[State Clearinghouse No. 2008121080]

## **Los Angeles International Airport (LAX) Bradley West Project**

## **Responses to Comments and Corrections and Additions to the Draft EIR**

Figure 4.2-3c

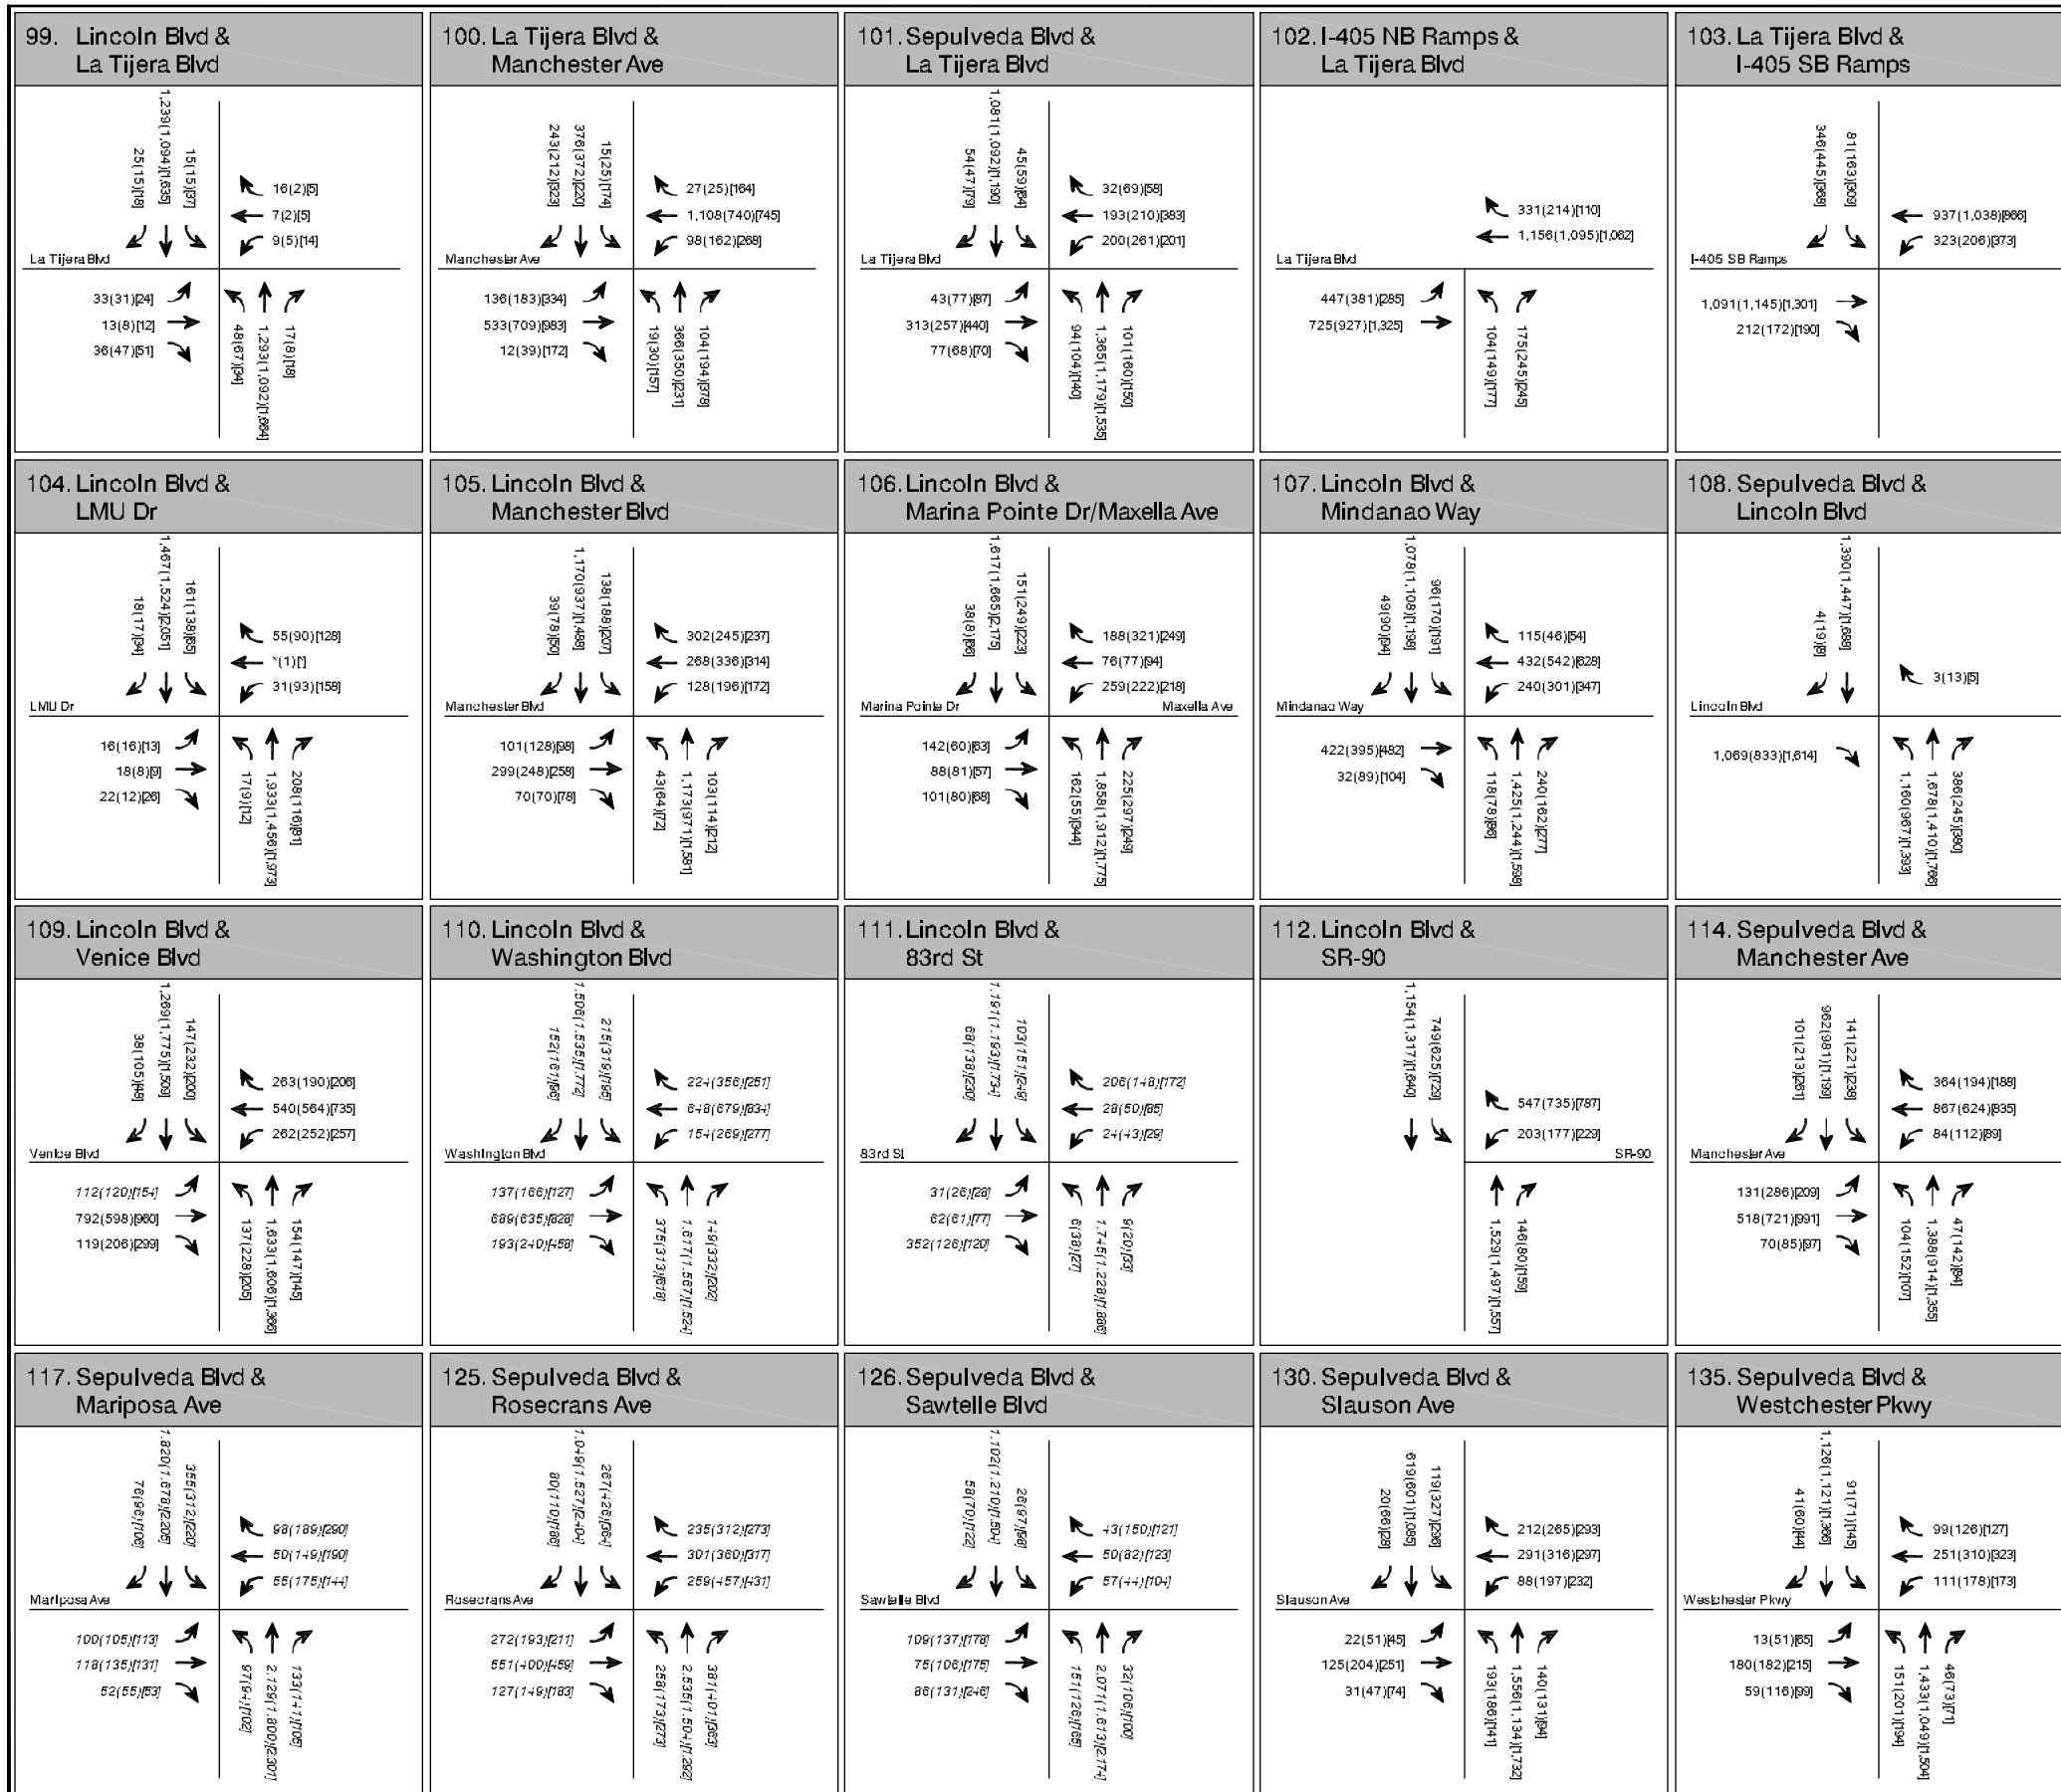
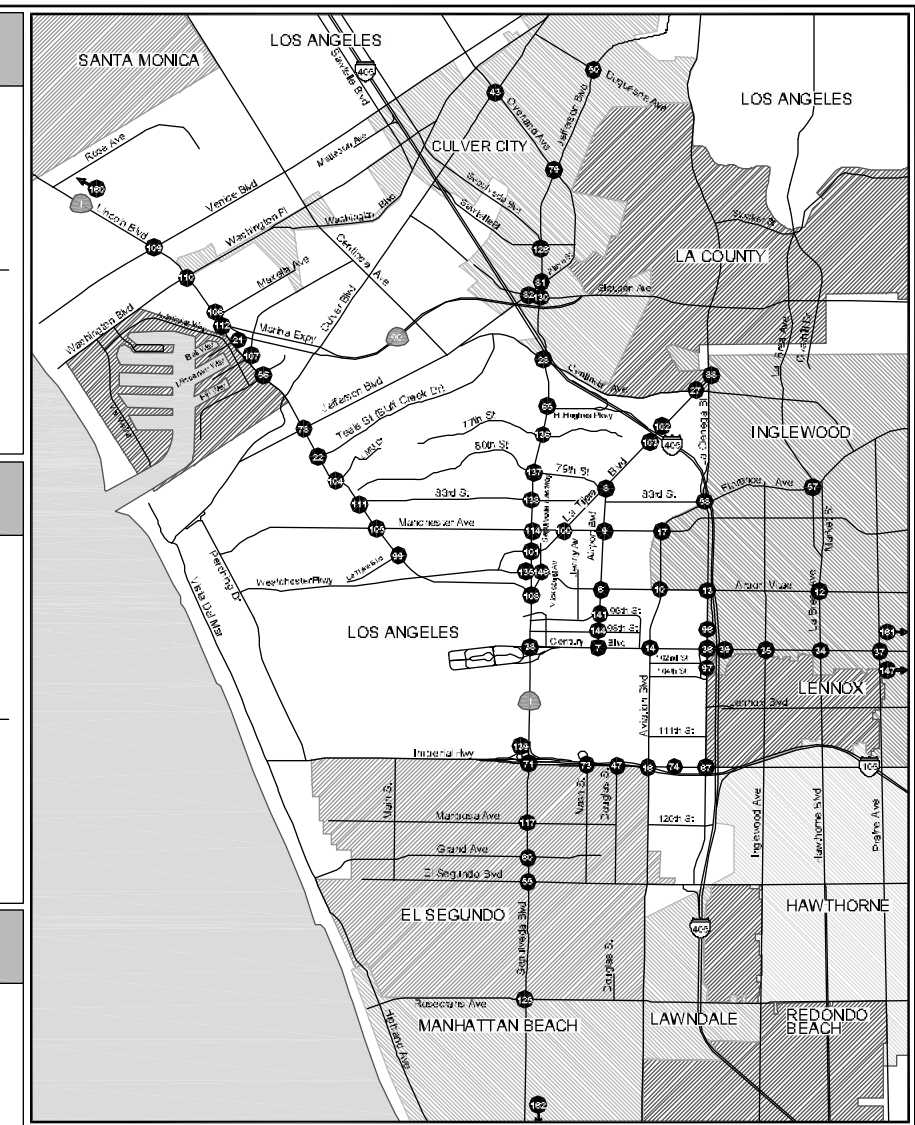
**Comment:** Volume 4, Appendix C-5, page 8, Lincoln Boulevard and Mindanao Way (Intersection #107): The eastbound AM left-turn vehicle count for Existing Conditions is not reflected in Volume 1, Figure 4.2-3c. Any similar omissions for Mid-day and PM peak eastbound left-turn counts and for other project scenarios should be corrected as needed.

**Comment:** Volume 4, Appendix C-5, page 8, Lincoln Boulevard and Venice Boulevard (Intersection #109): The eastbound AM left-turn vehicle count for Existing Conditions does not match the count shown in Volume 1, Figure 4.2-3c; similar errors occur with the Mid-day and PM peak eastbound left-turn counts. All intersection capacity analysis effected by these errors should be revised accordingly and corresponding mitigation measures and potential improvements should be identified and evaluated for any anticipated significant impacts. If similar errors occur for other project scenarios (e.g. "No Project," "Plus Project" etc.) then capacity analysis calculations and any resulting potential mitigation measures should also be revised accordingly.

**Comment:** Volume 4, Appendix C-5, page 9, Lincoln Boulevard and Washington Boulevard (Intersection # 110): The AM peak vehicle counts for Existing Conditions do not match those shown in Volume 1, Figure 4.2-3c; similar errors occur with the Mid-day and PM peak vehicle counts. All intersection capacity analysis effected by these errors should be revised accordingly and corresponding mitigation measures and potential improvements should be identified and evaluated for any anticipated significant impacts. If similar errors occur for other project scenarios (e.g. "No Project," "Plus Project" etc.) then capacity analysis calculations and any resulting potential mitigation measures should also be revised accordingly.

**Comment:** Volume 4, Appendix C-5, page 9, Lincoln Boulevard and 83rd Street (Intersection #111): The AM peak vehicle counts for Existing Conditions do not match those shown in Volume 1, Figure 4.2-3c; similar errors occur with the Mid-day and PM peak vehicle counts. All intersection capacity analysis effected by these errors should be revised accordingly and corresponding mitigation measures and potential improvements should be identified and evaluated for any anticipated significant impacts. If similar errors occur for other project scenarios (e.g. "No Project," "Plus Project" etc.) then capacity analysis calculations and any resulting potential mitigation measures should also be revised accordingly.

**Response:** The typographical error is noted. In response, the eastbound AM, Mid-day and PM left-turn volumes for the Lincoln Boulevard and Venice Boulevard intersection in Figure 4.2-3c on page 4-107 of the Bradley West Project Draft EIR have been revised. Please see Chapter 3, Corrections and Additions to the Bradley West Project Draft EIR. The volumes used in the existing (2008) traffic conditions intersection analysis match the existing counts (as shown in Appendix C-4) for all analyzed periods; therefore, the existing (2008) traffic conditions analysis is not affected and no additional revisions are required.

**Response:** The typographical error is noted. In response, the volume figure for the Lincoln Boulevard and Washington Boulevard intersection in Figure 4.2-3c on page 4-107, Figure 4.2-4c on page 4-141, and Figure 4.2-5c on page 4-149 of the Bradley West Project Draft EIR has been revised. Please see Chapter 3, Corrections and Additions to the Bradley West Project Draft EIR. However, the revised Mid-day southbound through volume at the Lincoln Boulevard and Washington Boulevard intersection does not match the vehicle counts because the volume was adjusted to be consistent with the traffic volumes at nearby intersections. As stated on page 4-90 in Section 4.2 of the Bradley West Project Draft EIR, traffic volumes, counted or forecasted, are balanced to ensure a reasonable amount of vehicles are either gained or lost between adjacent intersections. The volumes used in the intersection analysis for all scenarios match the revised volumes for all periods; therefore, the intersection analysis is not affected and no additional revisions are required.

**Response:** The typographical error is noted. In response, the volume figure for the Lincoln Boulevard and 83rd Street intersection in Figure 4.2-3c on page 4-107, Figure 4.2-4c on page 4-141, and Figure 4.2-5c on page 4-149 of the Bradley West Project Draft EIR has been revised. Please see Chapter 3, Corrections and Additions to the Bradley West Project Draft EIR. However, the revised AM and Mid-day northbound and southbound through volumes at the Lincoln Boulevard and 83rd Street intersection do not match the vehicle counts because the volume was adjusted to be consistent with the traffic volumes at nearby intersections. As stated on page 4-90 in Section 4.2 of the Bradley West Project Draft EIR, traffic volumes, counted or forecasted, are balanced to ensure a reasonable amount of vehicles are either gained or lost between adjacent intersections. The volumes used in the intersection analysis for all scenarios match the revised volumes for all periods; therefore, the intersection analysis is not affected and no additional revisions are required.

4. Figures 4.2-3b on page 4-105, 4.2-3c on page 4-107, and 4.2-3d on page 4-109 of the Draft EIR have been revised. Please see the following revised figures.
5. The last page of Table 4.2-5 on page 4-134 of the Draft EIR has been revised. Please see the following revised table.

Figure 4.2-4b

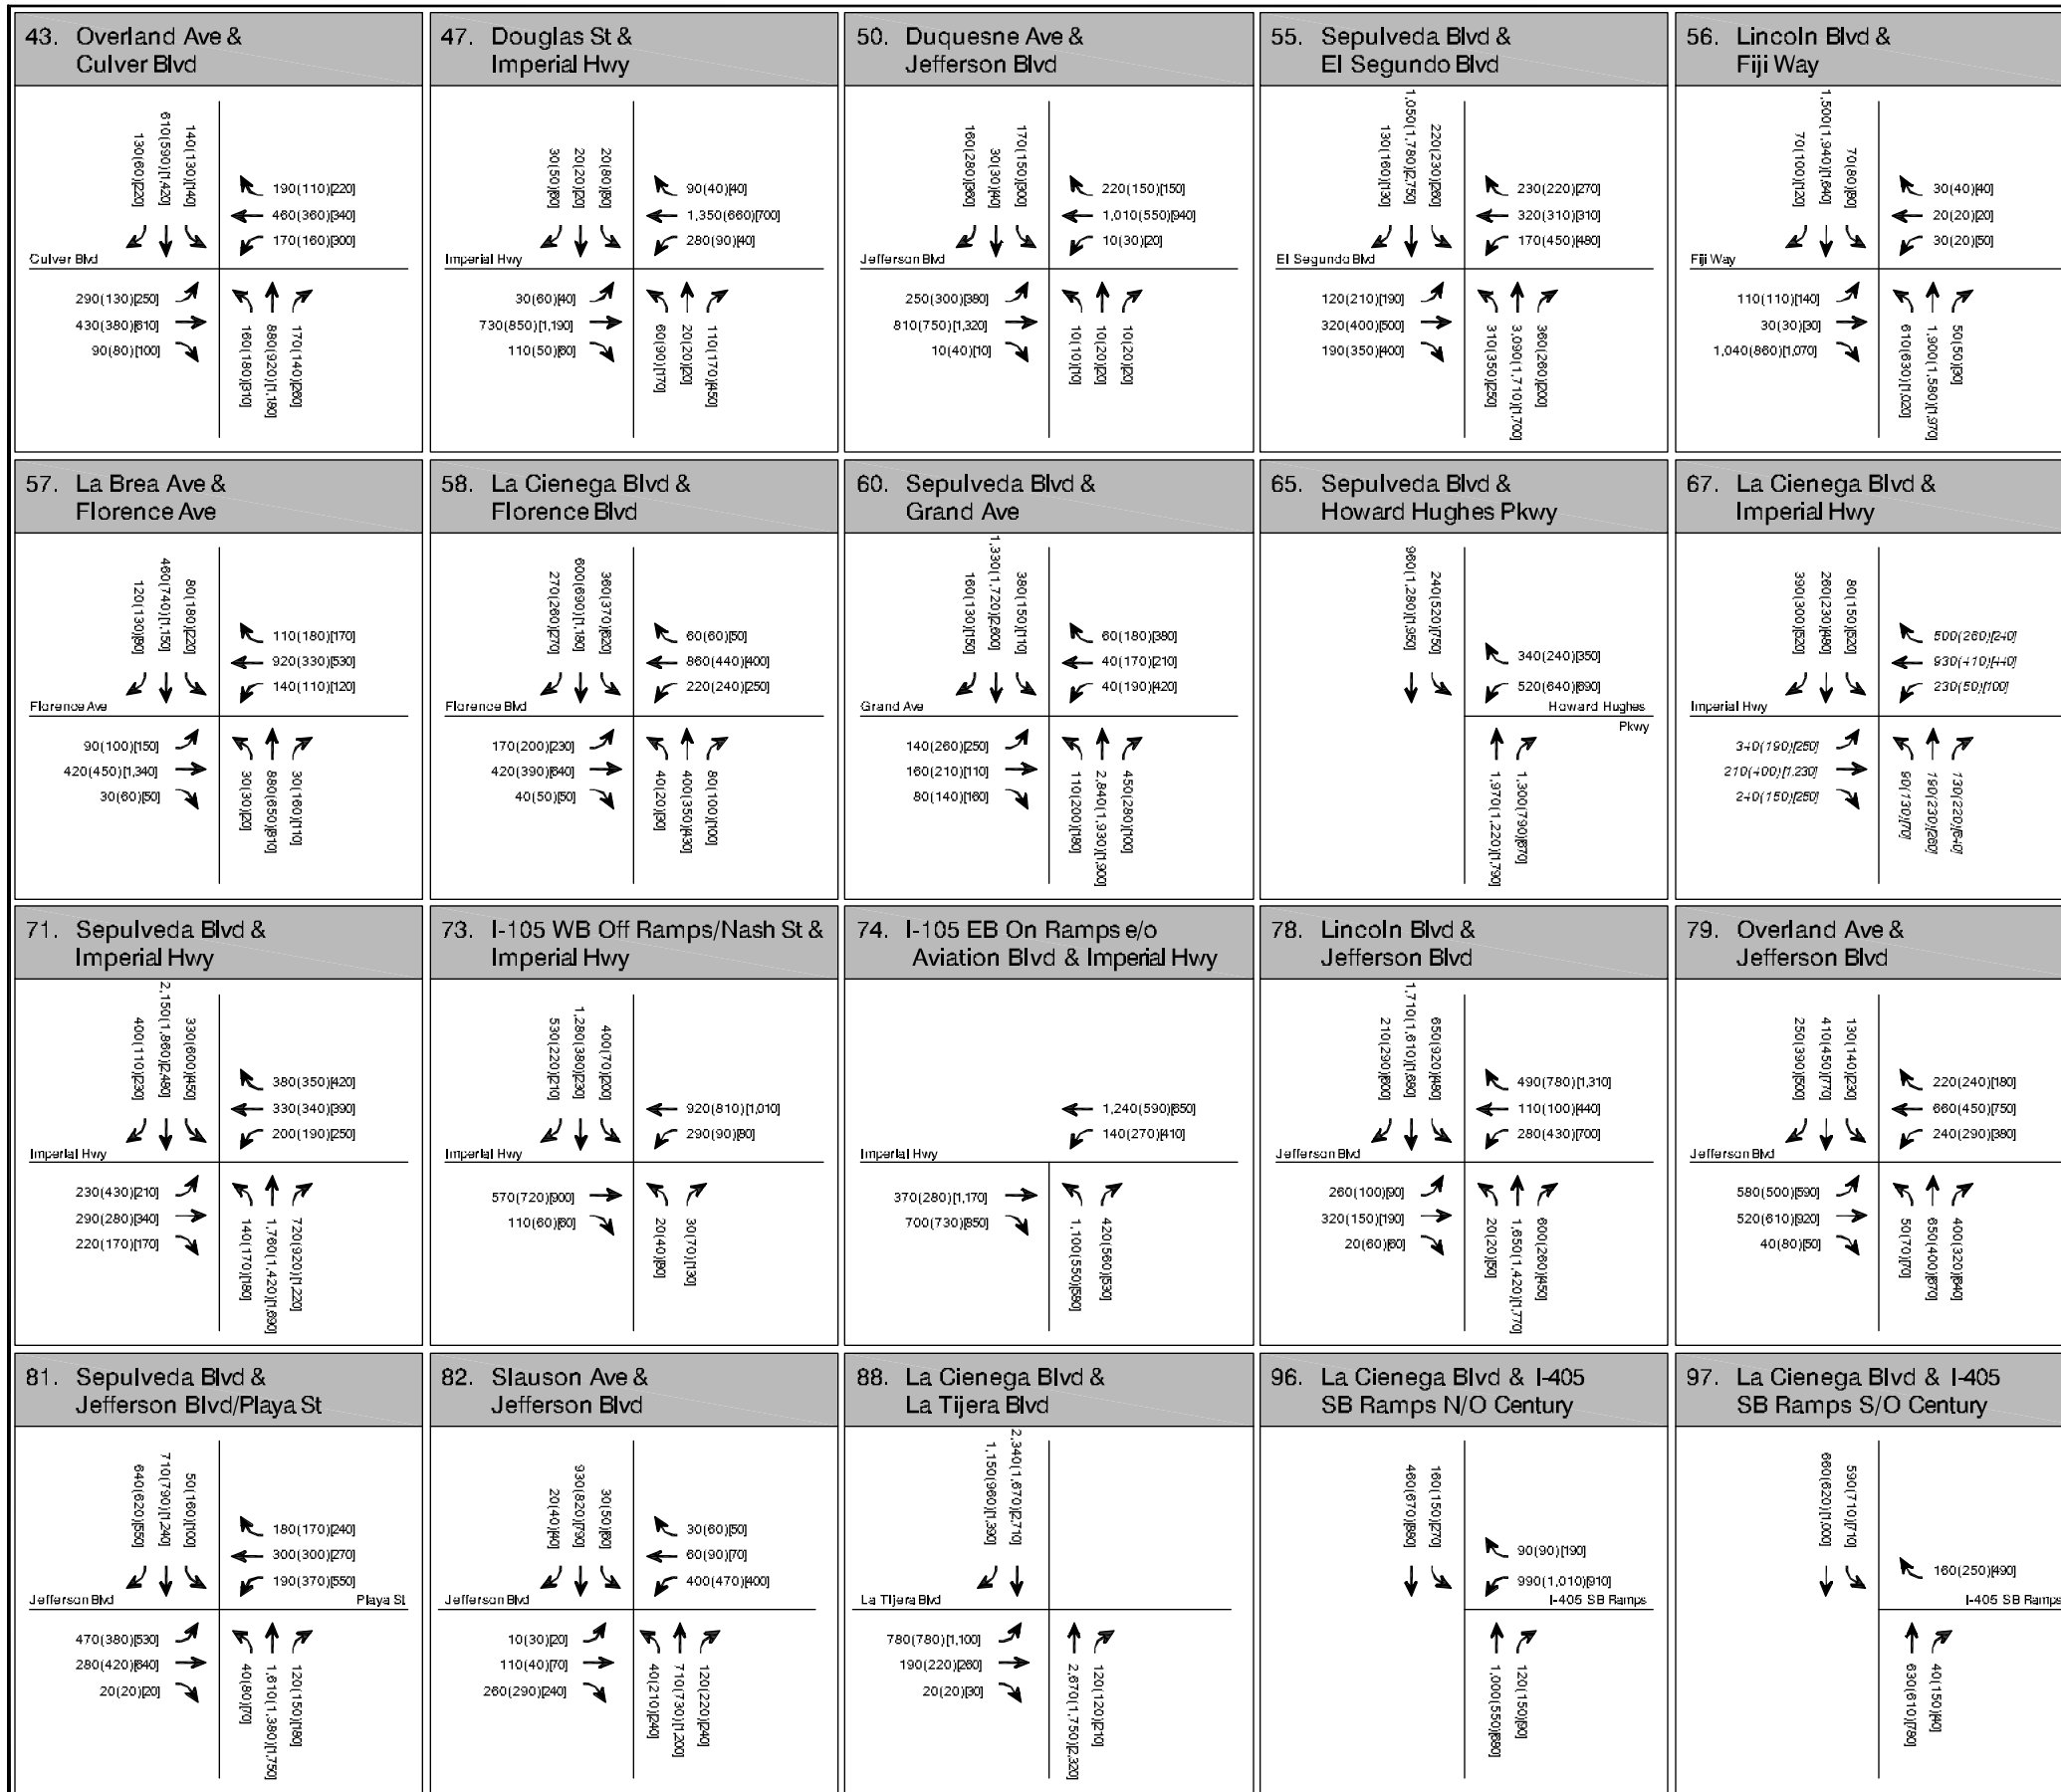
**Comment:** Volume 4, Appendix C-5, page 4, La Cienega Boulevard and Imperial Highway (Intersection # 67): The AM peak vehicle counts for Existing Conditions do not match those shown in Volume 1 (Main Document), Figure 4.2-3b; similar errors occur with the Mid-day and PM peak vehicle counts. All intersection capacity analysis effected by these errors should be revised accordingly and corresponding mitigation measures and potential improvements should be identified and evaluated for any anticipated significant impacts. If similar errors occur for other project scenarios (e.g. "No Project," "Plus Project" etc.) then capacity analysis calculations and any resulting potential mitigation measures should be also revised accordingly.

**Response:** The typographical error is noted. In response, Figure 4.2-3b on page 4-105, Figure 4.2-4b on page 4-139, and Figure 4.2-5b on page 4-147 of the Bradley West Project Draft EIR have been revised. Please see Chapter 3, Corrections and Additions to the Bradley West Project Draft EIR. The intersection capacity analyses under all scenarios are not affected by this typographical error as it only occurred in the figures. The correct values were used in the LOS calculations and hence no revisions to the LOS calculations are required.

6. Table 4.2-6 on page 4-135 of the Draft EIR has been revised. Please see the following revised table.
7. Figures 4.2-4b on page 4-139, 4.2-4c on page 4-141, and 4.2-4d on page 4-143 of the Draft EIR have been revised. Please see the following revised figures.
8. Figures 4.2-5b on page 4-147, 4.2-5c on page 4-149, and 4.2-5d on page 4-151 of the Draft EIR have been revised. Please see the following revised figures.
9. The third sentence of the first paragraph on page 4-154 of the Draft EIR is hereby revised as follows:
